City of Portland, Maine - Building or Use Permit Application 589 Congress Street, 04101, Tel: (207) 874-8703, FAX: 874-8716

Location of Construction: 41-A New Island Ave, Peaks Isl		Owner: Remington O. Schmidt		Phone: w) 773-1430 h) 766-5550		Permit No: 981107							
Owner Address: SAA 04108		Lessee/Buyer's Name:		Phone:		BusinessName:							
Contractor Name: SAA		Address:		Phone:		<div style="border: 2px solid black; padding: 5px; text-align: center;"> PERMIT ISSUED Permit Issued: SEP 29 1998 CITY OF PORTLAND </div>							
Past Use: 1-fam		Proposed Use:		COST OF WORK: \$ 1,000.00 PERMIT FEE: \$ 25.00		INSPECTION: Use Group: Type: B BOX A 76 Signature: 7/1/98							
Proposed Project Description: New Porch w/doors & windows		PEDESTRIAN ACTIVITIES DISTRICT (P.A.D.) Action:

BUILDING PERMIT REPORT

DATE: 27 Sept. 98 ADDRESS: 41-A New Island AVE. Pt. 084-N-026+
 REASON FOR PERMIT: New Porch w/doors & windows.
 BUILDING OWNER: R. O. Schmidt.
 CONTRACTOR: SAA
 PERMIT APPLICANT: SAA
 USE GROUP R-3 BOCA 1996 CONSTRUCTION TYPE 5B

Peaks Island Porch Specifications
Lots 84-N-27 & 84-N-26
R.O. "Ted" Schmidt

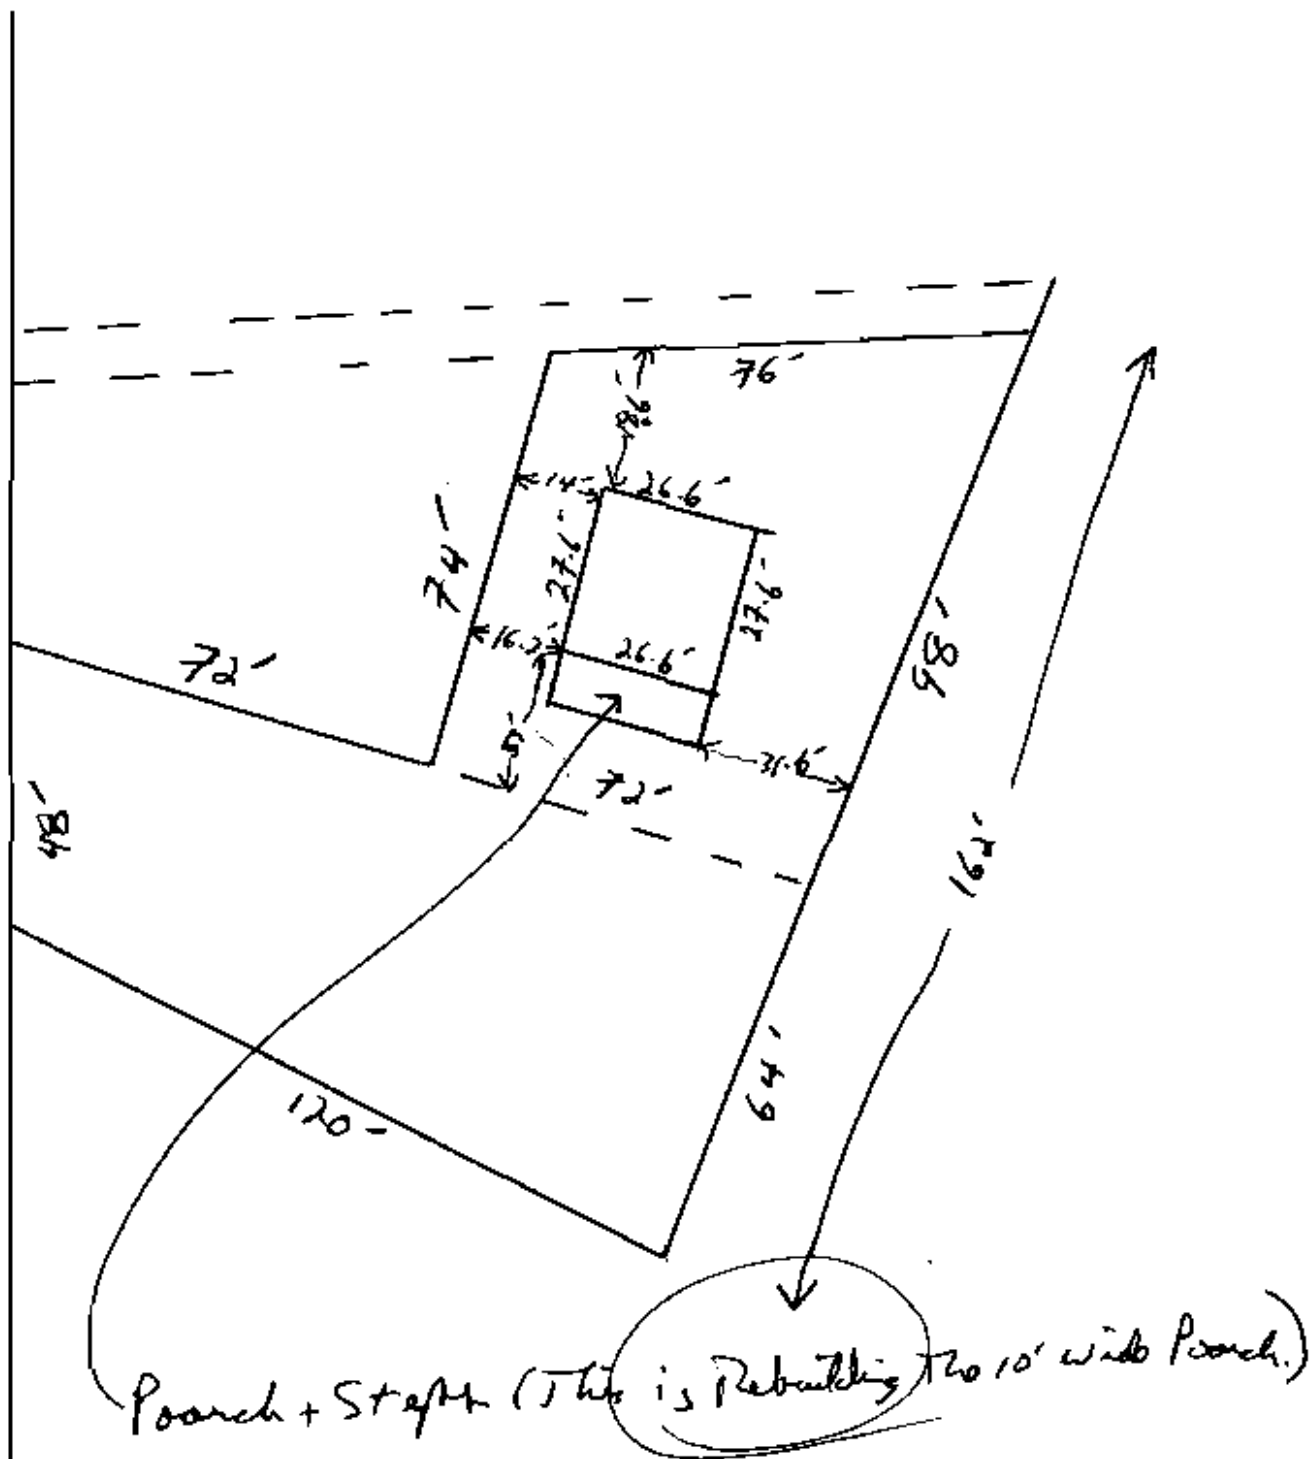
- *28. Please read and implement the attached Land Use-Zoning report requirements. → porch not to exceed existing footprint
- *29. The proposed 2x6" rafters @ 16" OC. 10' - 1" span does NOT meet The City's building code - A minimum of 2x8" @ 16" IS required.
